Determination 2021/014

Regarding compliance with the Building Act of an existing pool barrier at 542 Remuera Road, Auckland

Summary

Figure 2: Sketch of gate and adjacent sections of barrier (not to scale)

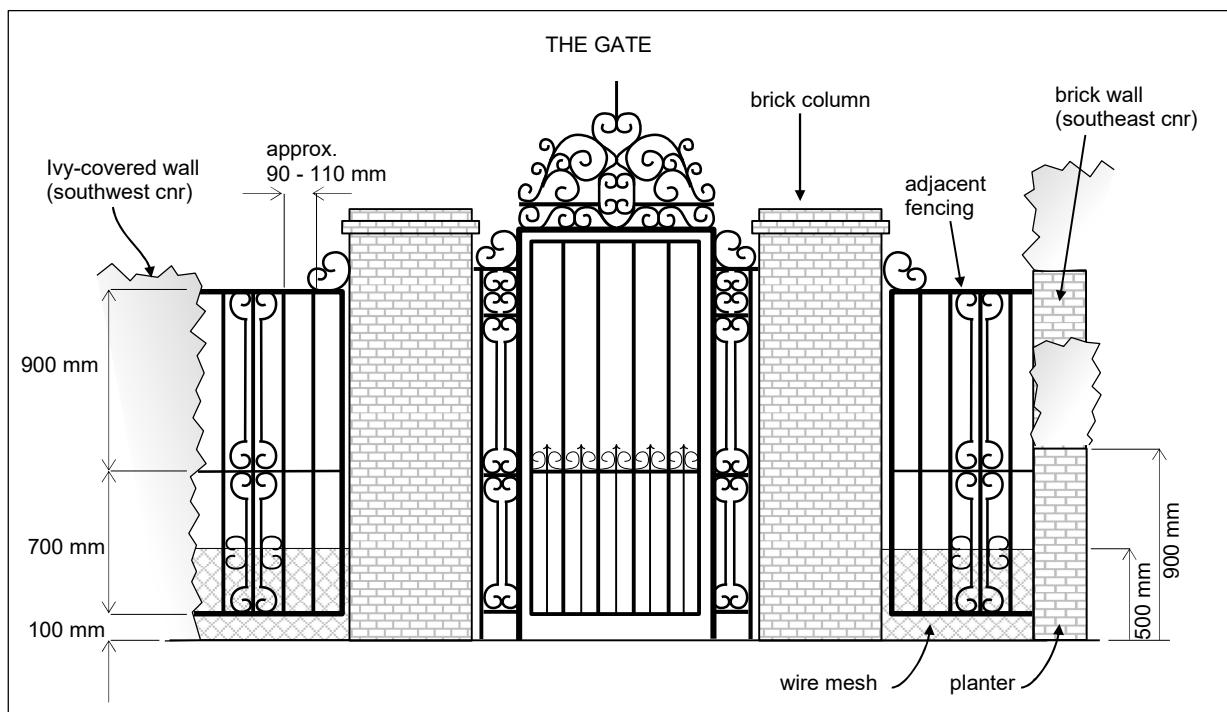
- 5.4.1 There is no doubt the gate is a substantial height at 2000 mm. However, the small sections of fence between the opening section of the gate and the brick columns, and the adjacent fencing (1700 mm high) on the other side of the brick columns have horizontal members spaced closer than 900 mm apart vertically⁹ and gaps between vertical members that would provide a footing for a young child climbing the barrier. I note also some of the gaps may be greater than 100 mm. I have insufficient information about the bollard to assess whether it impacts on the compliance of the barrier, but the planter in the southeast corner is a permanent feature within 1200 mm of the top of the brick wall that could assist a child in climbing.

- 5.4.2 Therefore, the gate and adjacent fencing and the sections of brick wall at the southeast corner do not satisfy either the Schedule or Acceptable Solution F9/AS1.

- 5.4.7 Children only require a small area to use as a foot or handhold. I am of the view the climbable features, which include the horizontal rails and the metal scroll decorations in both the sections between the opening part of the gate and the brick columns, and the adjacent fencing on the other side of the brick columns (as described in paragraph 5.4.1) provide hand and footholds that would assist young children in negotiating the barrier. The barrier also does not comply with regard to the planter in the southeast corner, which is a permanent object on the outside of the barrier that could assist children in negotiating the barrier.

- 5.4.8 I am of the view the height of the gate and adjacent fencing is not a sufficient mitigating feature to compensate for the climbable features. I consider there is a lower level of protection than is required by Clause F9.3.1 of the Building Code for a physical barrier that restricts access to the pool by unsupervised children under five years of age.

Figure 3: Indicative plan (not to scale)

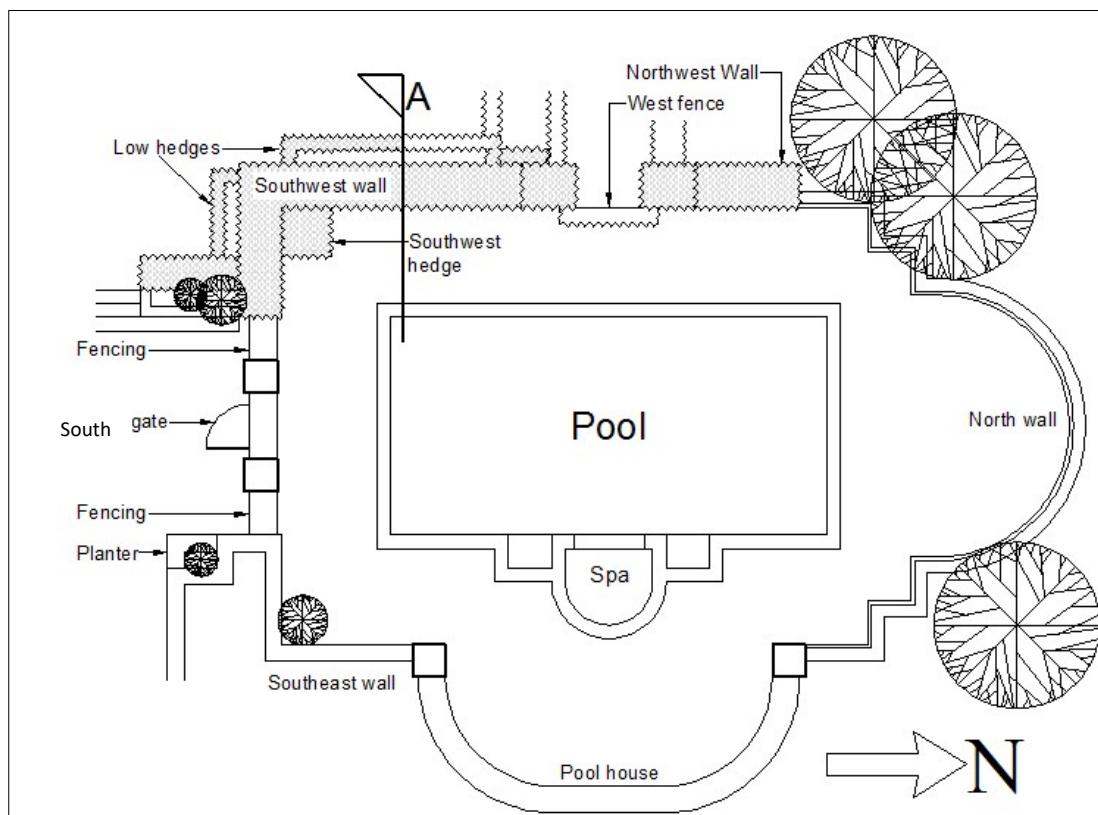
- 2.5 A high ivy-covered brick wall completes the fencing on the southwest corner of the barrier, and a brick wall completes the southeast corner (see figure 3). A lower section of brick wall containing some vegetation (“the planter”) is incorporated in the southeast wall; the planter is approximately 900 mm above the ground level.

- 2.6 The southwest wall (refer Figure 3) is approximately 2100 mm above the level of the immediate pool area⁴ and the non-pool side ranges in height between approximately 800 – 900 mm (refer Figure 4). At its highest point the southwest wall is approximately 800 mm wide. Covering the southwest wall is a dense ivy.
- 2.7 On the non-pool side of the southwest wall is a hedge approximately 400 mm high which spans most of the length of the southwest wall.

Figure 4: Section A through the southwest wall (not to scale)

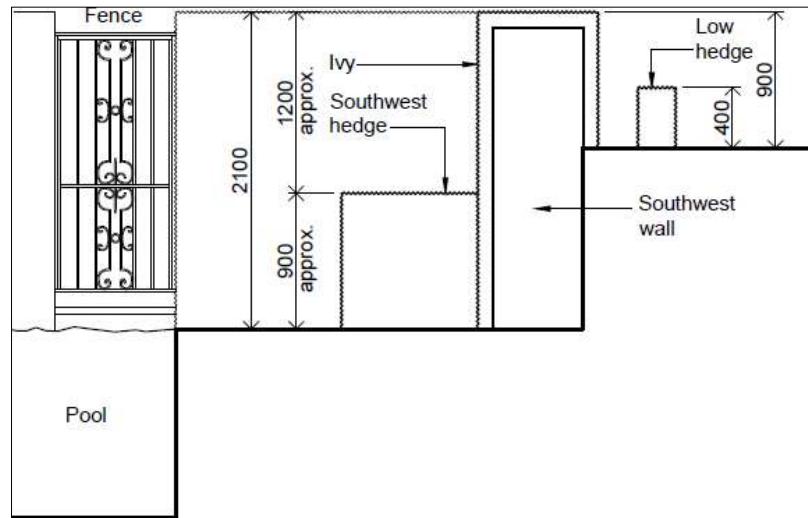
- 5.5.2 The height of the southwest wall on the outside is less than 1200 mm. Therefore, the southwest wall does not meet the criteria in F9/AS1 or the Schedule of FOSPA as an Acceptable Solution. I will now consider whether it complies as an alternative solution.
- 5.5.3 The owner is of the view the southwest wall is comparable to a pool barrier on a property boundary in F9/AS1, in that if a child was able to reach the top of the

5.5.6 However, at the time the application for this determination was made, dense ivy covered the southwest wall and there was an approximately 900 mm high hedge in the southwest corner that would present a less daunting pathway into the immediate pool area from the top of the southwest wall. I am of the view the ivy and hedge could assist a young child to climb or clamber down into the immediate pool area in a similar manner to a rail, rod or wire that is not vertical or a horizontal projection or indentation (neither permitted under F9/AS1 paragraphs 2.1.3 and 2.1.7).

5.5.9 I am of the view, taking into account the features that would assist a young child negotiating the barrier on the poolside, the height of the southwest wall on the pool side is not a sufficient mitigating feature to compensate for the lower height of the barrier from the outside. Therefore, the southwest wall does not comply with Clause F9.3.1 as a physical barrier that restricts access to the pool by unsupervised children under five years of age.

Photo 1: Panel adjacent to gate

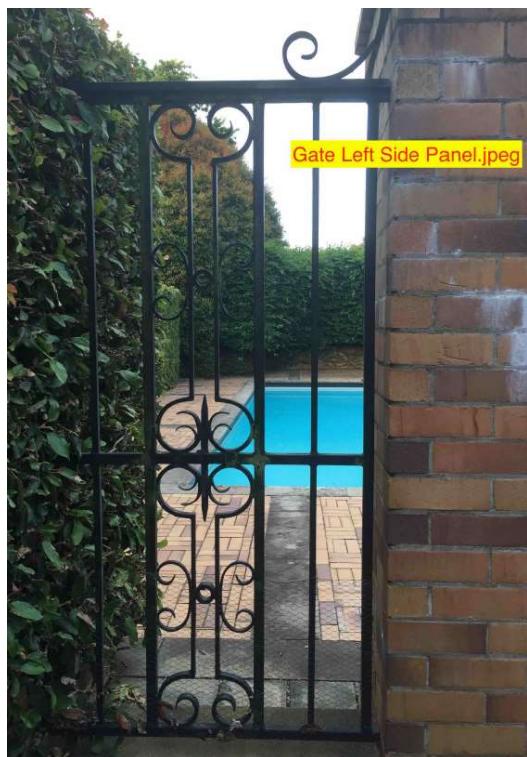
2. Fencing horizontal rails and climbable features are at least 900mm apart (i.e barrier has 900mm no climb zone) (Fail) Gate and side panels to be covered to eliminate climb points

⁹ The information I have received does not confirm whether the wire mesh installed to the adjacent sections of metal fencing has been installed on the outside of the pool fence to prevent the lowest horizontal member being used as a foothold. Regardless, the top of the scroll detail would also provide a footing that is accessible from outside the barrier and is closer than 900 mm to the next horizontal member.
